SUBJECT: Transmittal of Revised Responses to AP1000 DSER Open Items

**AP1000 Design Certification Review
Draft Safety Evaluation Report Open Item Non-Proprietary Responses**

DSER Open Item Number: 3.6.3.4-2 Addendum 1 Revision 2

Figure 27 - Bounding Analysis Curve – Normal RHR Suction – 12"

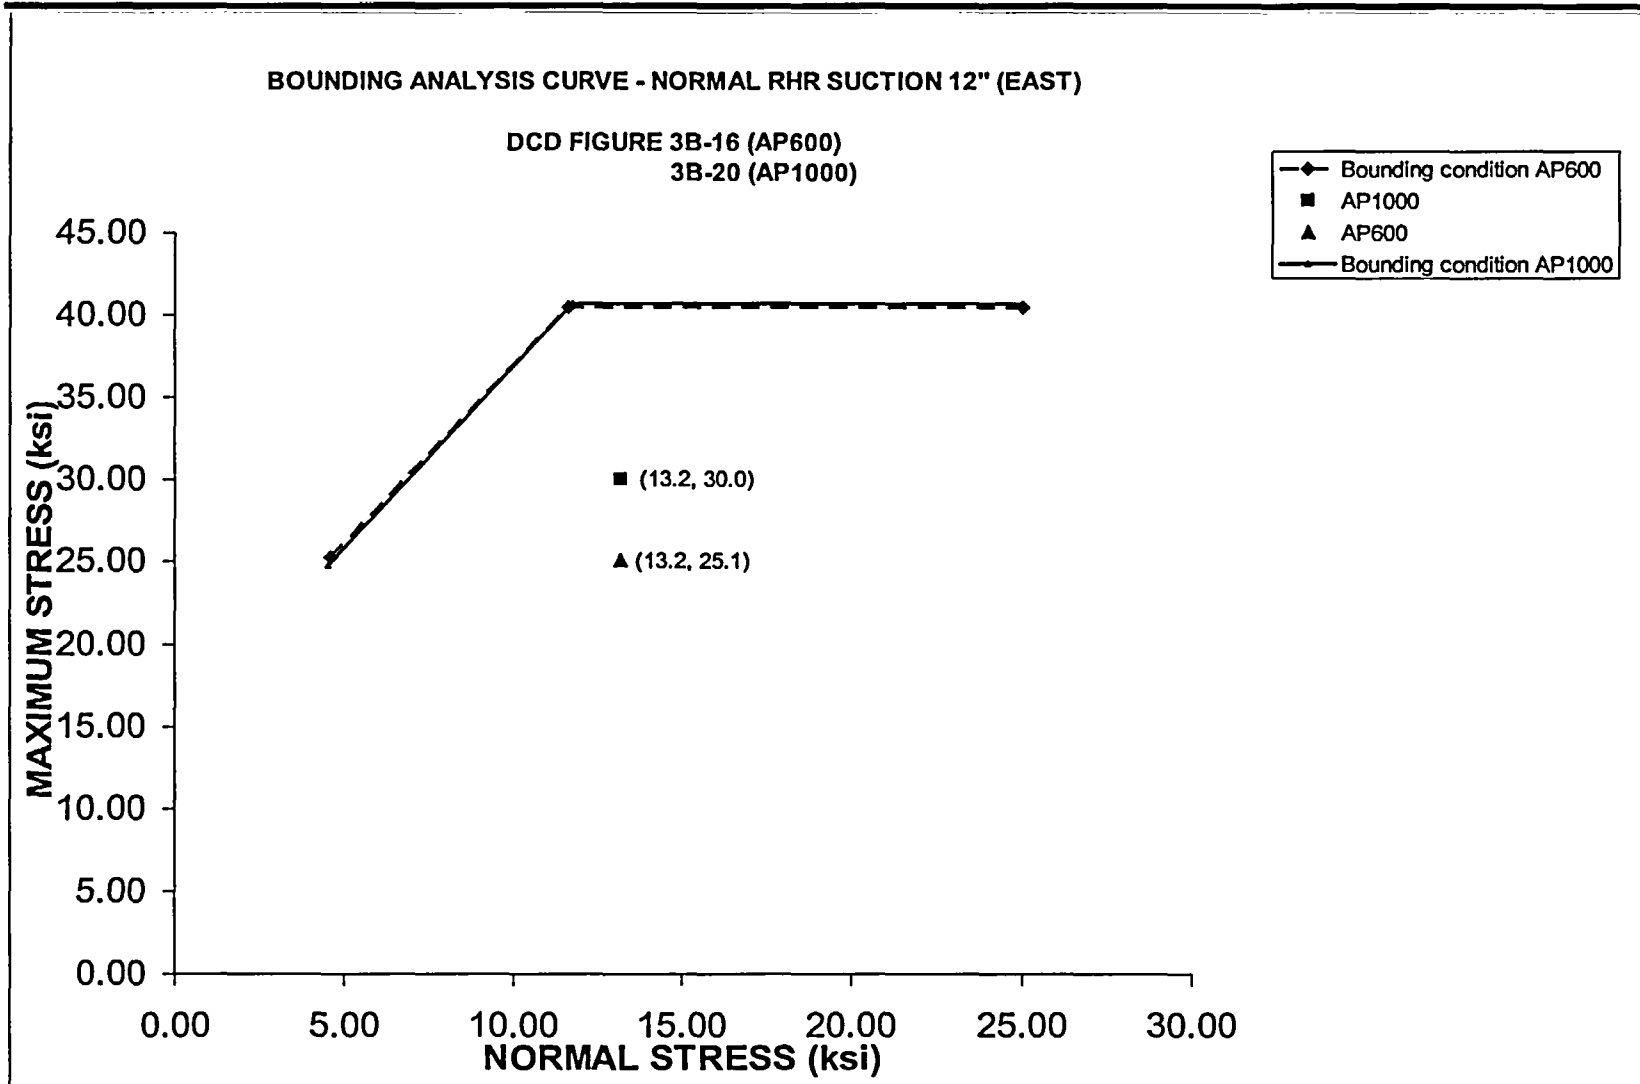
support in the East subcompartment. The maximum stress is 30.0 ksi which is less than the BAC stress of 40.7 ksi. Figure 27 shows the BAC and the estimated stresses for the AP1000 plant. The feasibility of LBB for AP1000 is confirmed.

Figure 38 : Bounding Seismic Increase Factors -
Seismic Response Spectra, Steam Generator Support Elev. 135', (North-South) – 4th Stage ADS

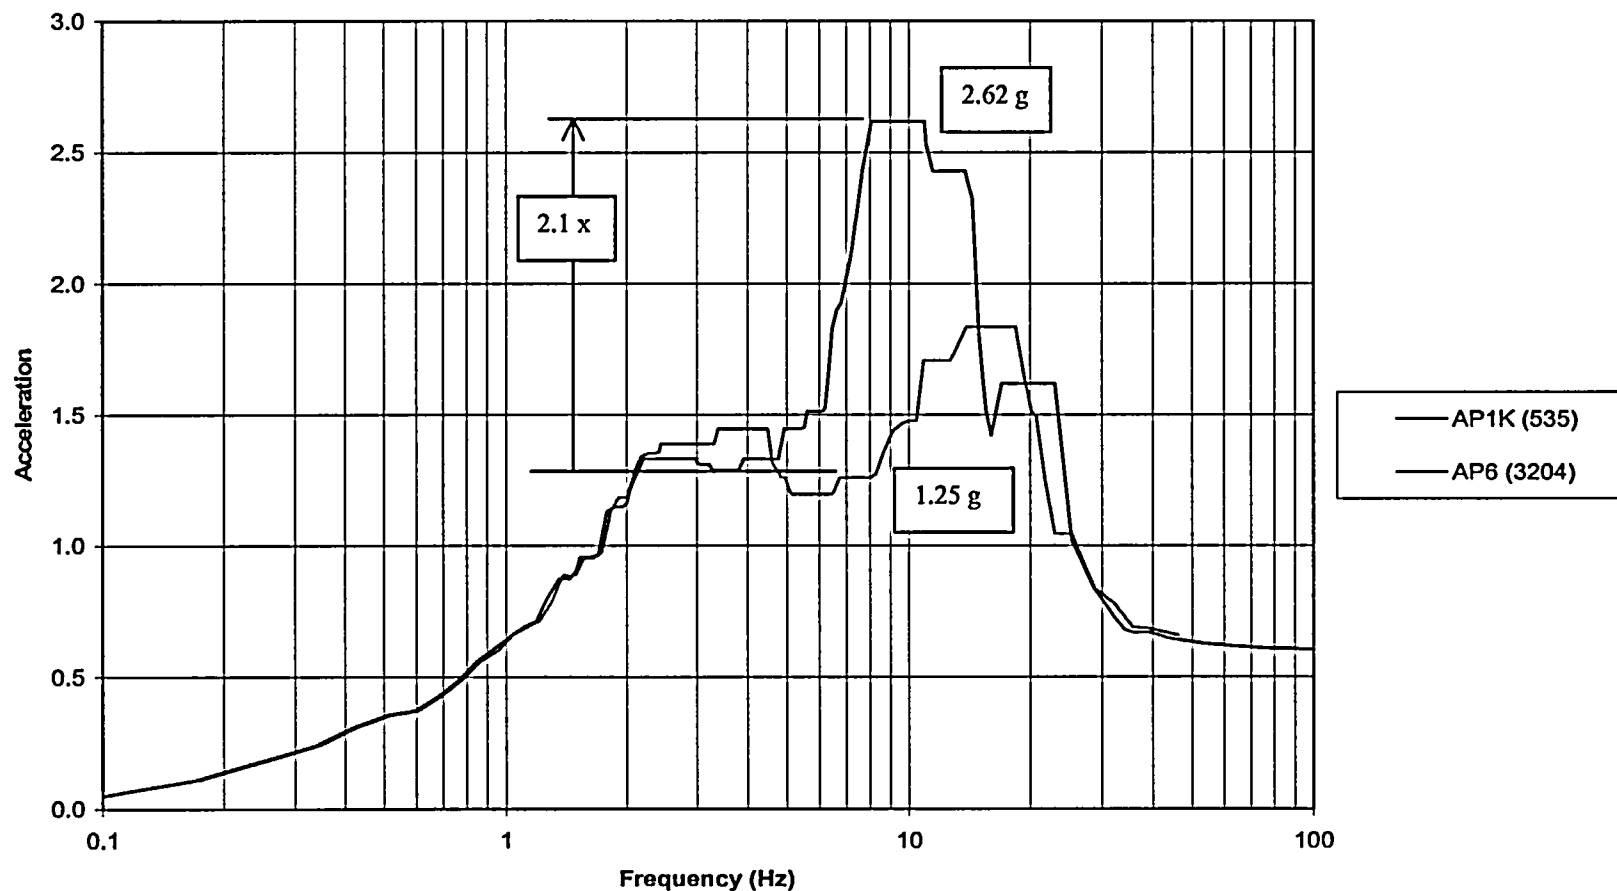
Due to the critical nature of this system, an additional assessment of the seismic loadings is performed to further demonstrate the feasibility of Leak-Before-Break for these lines. The applicable seismic response spectra are reviewed for the 4th stage ADS, East and West, and the maximum increase in response spectra acceleration identified based on individual frequency. This review results in the following seismic increase factors as shown in Figures 38 and 39:

The ADS Stage 4 pipe diameter is larger than the AP600 (12"). Per Figure 38, the seismic increase factor is 2.1 based on the seismic response spectra at approximately 8 Hz. The maximum stress is 33.0 ksi accounting for both the seismic increase factor and the increase in pipe diameter. The adjusted stress is less than the BAC stress of 40.7 ksi. Figure 40 shows the BAC and the estimated stresses for the AP1000 plant. Feasibility of LBB for AP1000 is confirmed.

The ADS Stage 4 pipe diameter is larger than the AP600 (10"). Per Figure 38, the seismic increase factor is 2.1 based on the seismic response spectra at approximately 8 Hz. The maximum stress is 38.0 ksi accounting for both the seismic increase factor and the increase in pipe diameter. The adjusted stress is less than the BAC stress of 40.7 ksi. Figure 41 shows the BAC and the estimated stresses for the AP1000 plant. Feasibility of LBB for AP1000 is confirmed.

The ADS Stage 4 pipe diameter is larger than the AP600 (10"). Per Figure 38, the seismic increase factor is 2.1 based on the seismic response spectra at approximately 8 Hz. The maximum stress is 36.5 ksi accounting for both the seismic increase factor and the increase in pipe diameter. The adjusted stress is less than the BAC stress of 51.9 ksi. Figure 42 shows the BAC and the estimated stresses for the AP1000 plant. Feasibility of LBB for AP1000 is confirmed.

Figure 39 : Bounding Seismic Increase Factors
Seismic Response Spectra, Steam Generator Support Elev. 153' (East-West) – 4th Stage ADS

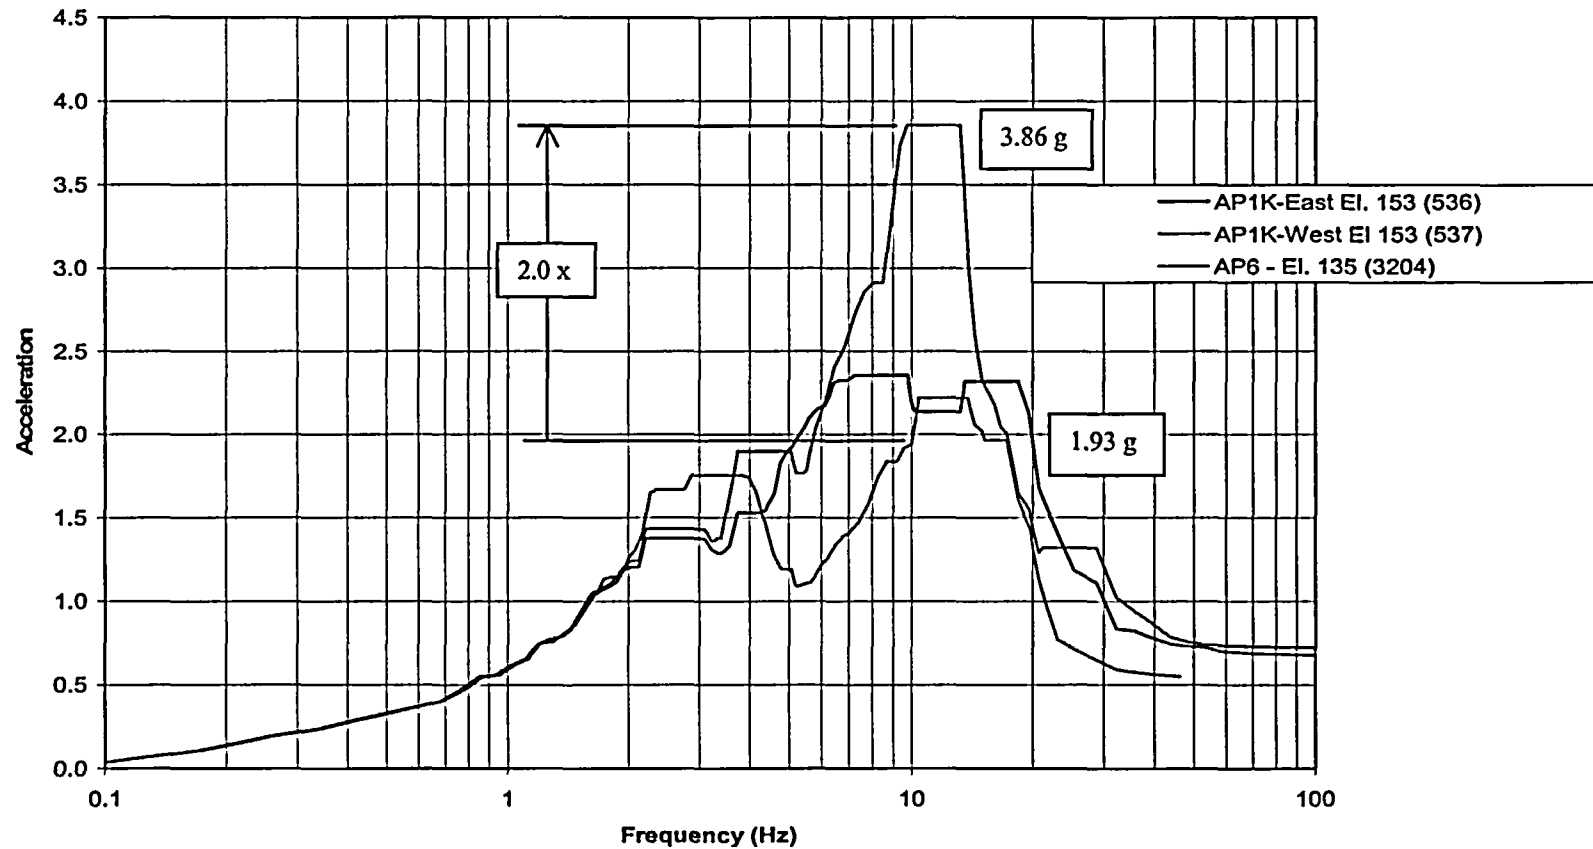
The ADS Stage 4 pipe diameter is larger than the AP600 (12"). Per Figure 39, the seismic increase factor is 2.0 based on the seismic response spectra at approximately 10 Hz. The maximum stress is 23.7 ksi accounting for both the seismic increase factor and the increase in pipe diameter. The adjusted stress is less than the BAC stress of 40.7 ksi. Figure 40 shows the BAC and the estimated stresses for the AP1000 plant. Feasibility of LBB for AP1000 is confirmed.

The ADS Stage 4 pipe diameter is larger than the AP600 (10"). Per Figure 39, the seismic increase factor is 2.0 based on the seismic response spectra at approximately 10 Hz. The maximum stress is 30.0 ksi accounting for both the seismic increase factor and the increase in pipe diameter. The adjusted stress is less than the BAC stress of 31.6 ksi. Figure 41 shows the BAC and the estimated stresses for the AP1000 plant. Feasibility of LBB for AP1000 is confirmed.

The ADS Stage 4 pipe diameter is larger than the AP600 (10"). Per Figure 39, the seismic increase factor is 2.0 based on the seismic response spectra at approximately 10 Hz. The maximum stress is 26.4 ksi accounting for both the seismic increase factor and the increase in pipe diameter. The adjusted stress is less than the BAC stress of 51.9 ksi. Figure 41 shows the BAC and the estimated stresses for the AP1000 plant. Feasibility of LBB for AP1000 is confirmed.

Figure 5.3-2

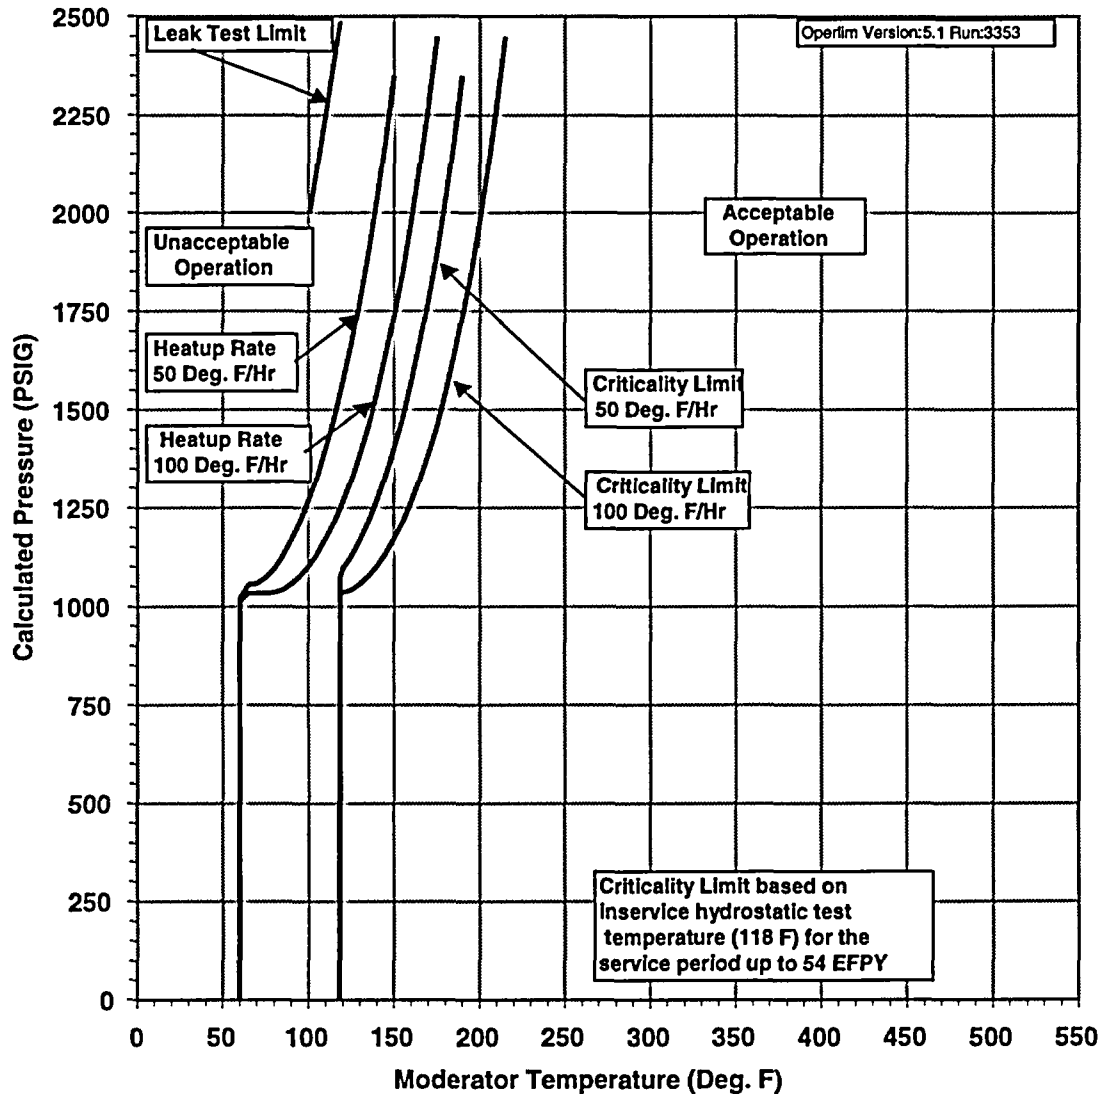
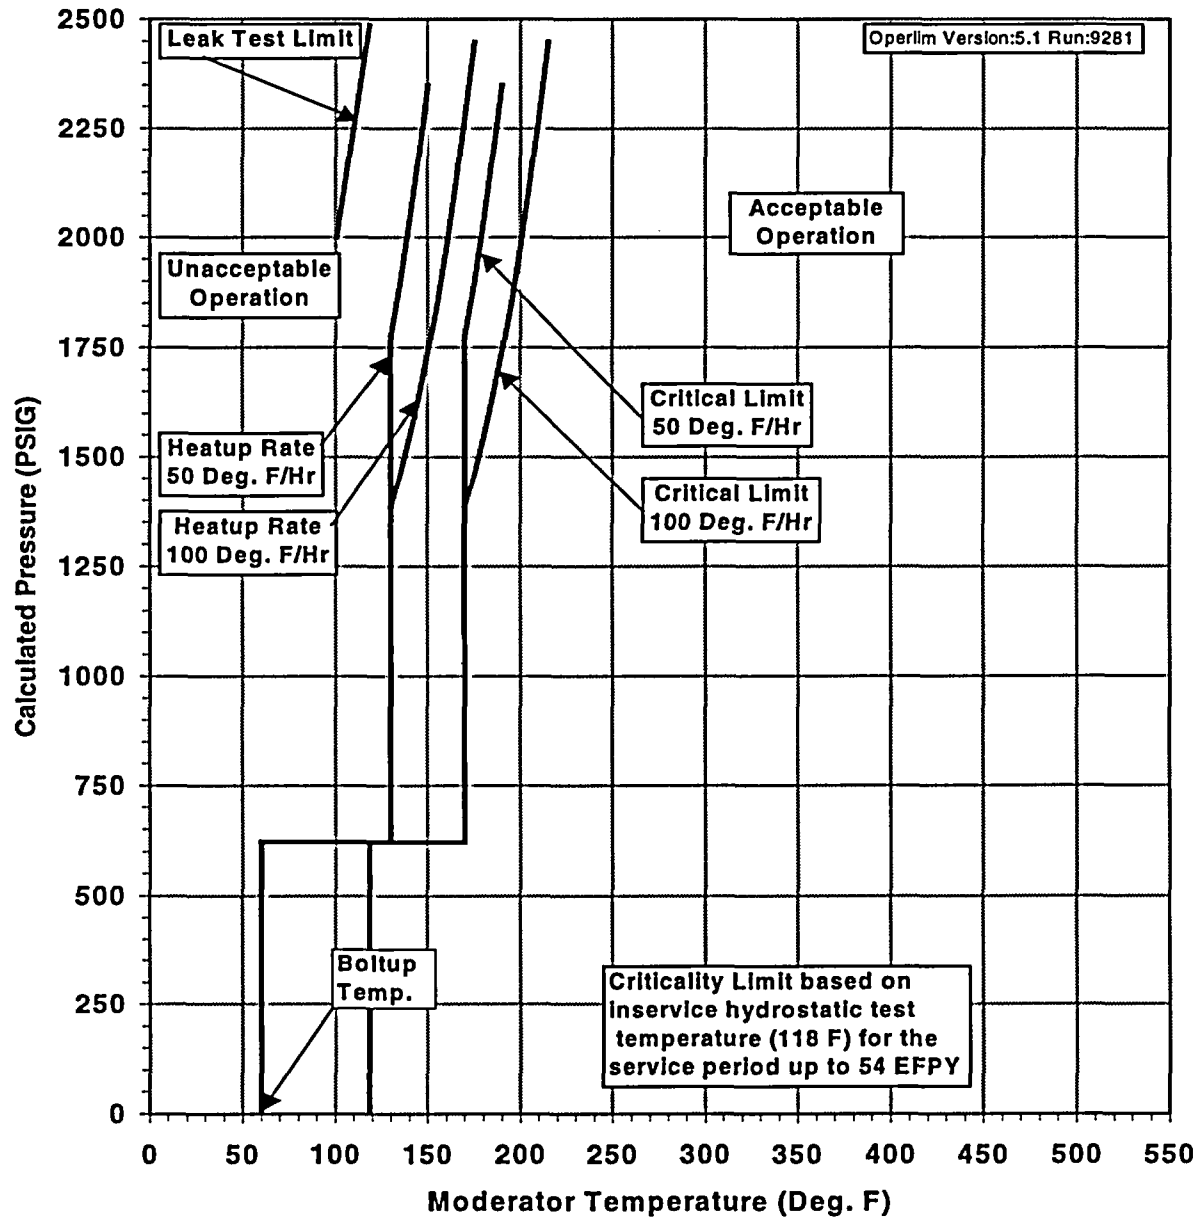
D. The LTOP enable temperature is based on utilizing the pressurizer safety valves for RCS overpressure protection when the RCS temperature is above 275 F (Technical Specification LCO 3.4.15). Once the RCS temperature reaches 275 F the RCS pressure can exceed the pressurizer safety valve set point pressure (2500 psig) and still be in the acceptable operating range according to the pressure/temperature curves (DCD Figures 5.3-2 and 5.3-3). The RCS pressure transients described in DCD section 15.2.3 confirm that the pressurizer safety valves are adequately sized to provide RCS overpressure protection.

Figure 19E.4.8-19

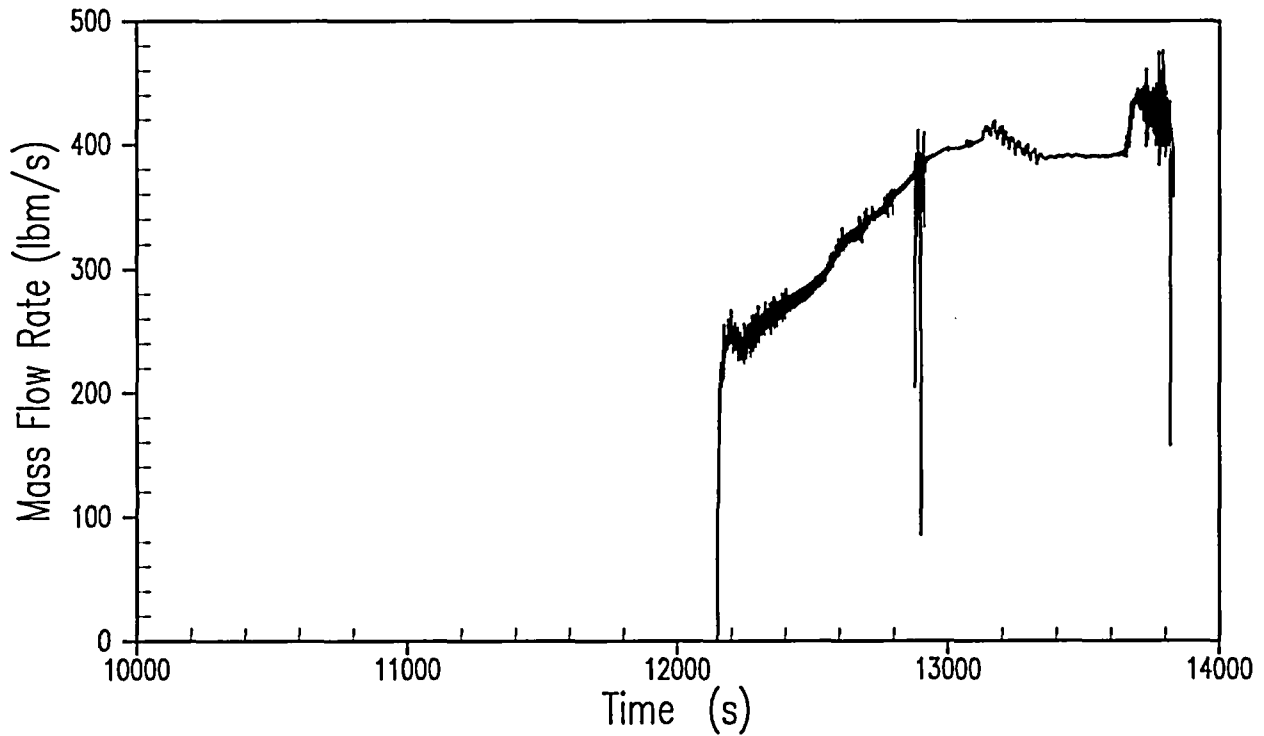
at ~~11,900~~10,225 seconds. As noted previously, it is assumed that one of the fourth-stage paths is out of service and one path is assumed to fail as the single active failure. The vapor and liquid flow through the fourth-stage ADS paths (Figures 19E.4.8-17 and 19E.4.8-18) further reduces the pressure to the point where IRWST injection begins at approximately ~~12,200~~10,700 seconds (Figure 19E.4.8-19).

Figure 19E.4.8-21

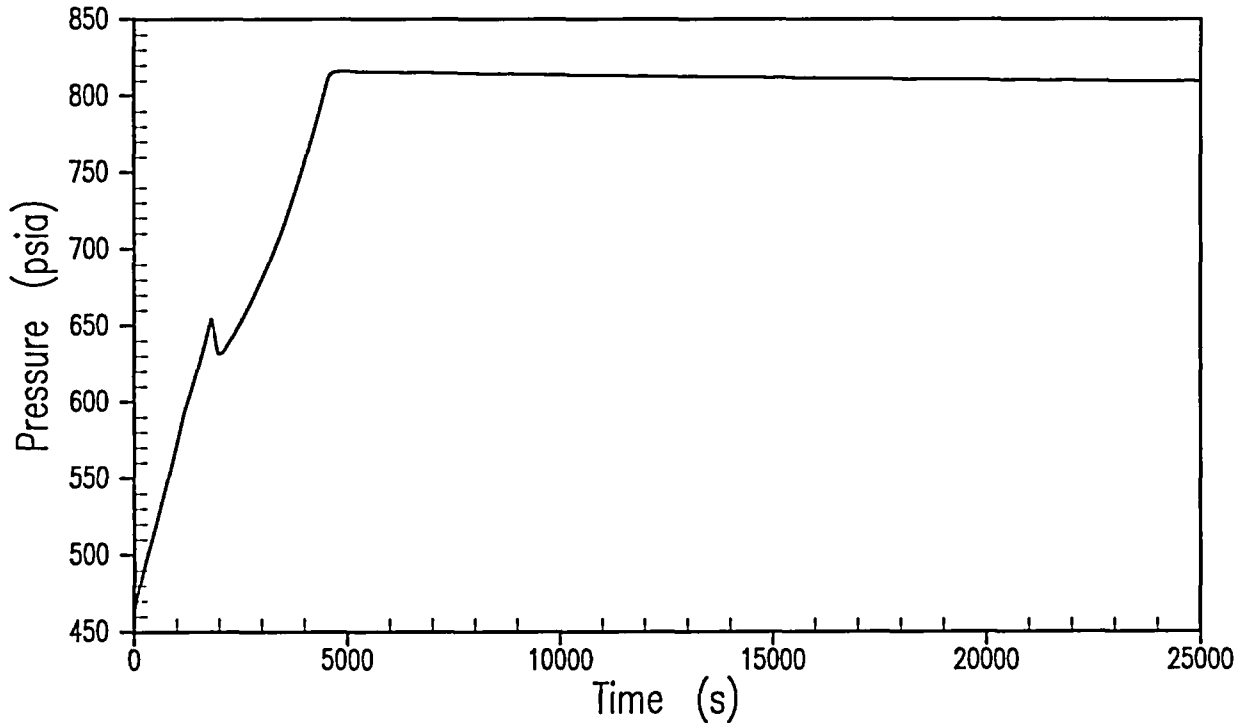
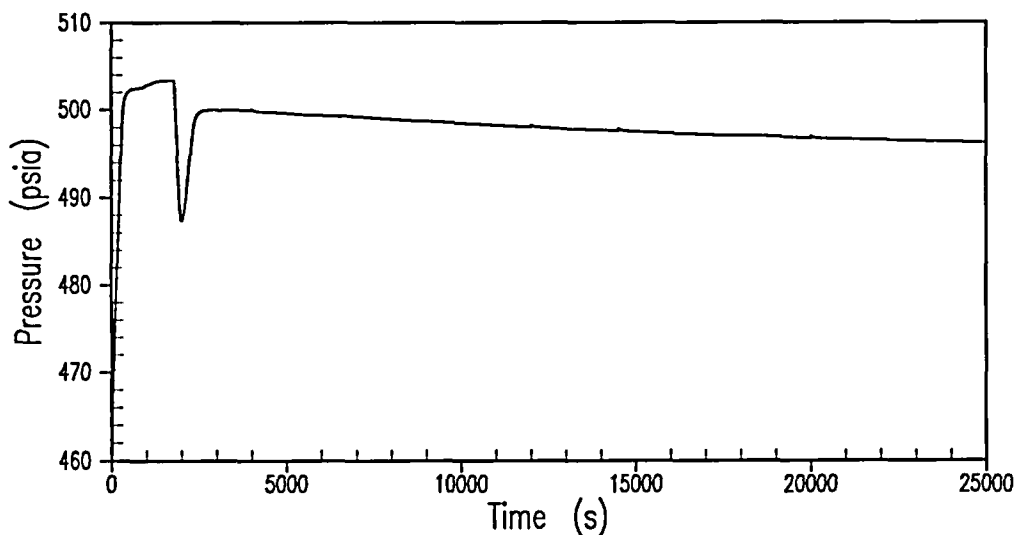
If operator action occurs after 1800 seconds, the CMT and PRHR isolation valves would open. Initially, the decay heat is greater than the PRHR capacity and the RCS pressure increases to the RNS safety valve setpoint (Figure 19E.4.8-21). At this time, RCS ~~a small amount of~~ inventory is vented through the valve (Figure 19E.4.8-22). Eventually, the decay heat matches the PRHR capacity (Figure 19E.4.8-42) and the RCS pressure decreases slowly to the valve setpoint. For this case, ~~no significant loss of inventory occurs and the ADS is not actuated.~~ The sequence of events for this case is also shown in Table 19E.4.8-2.
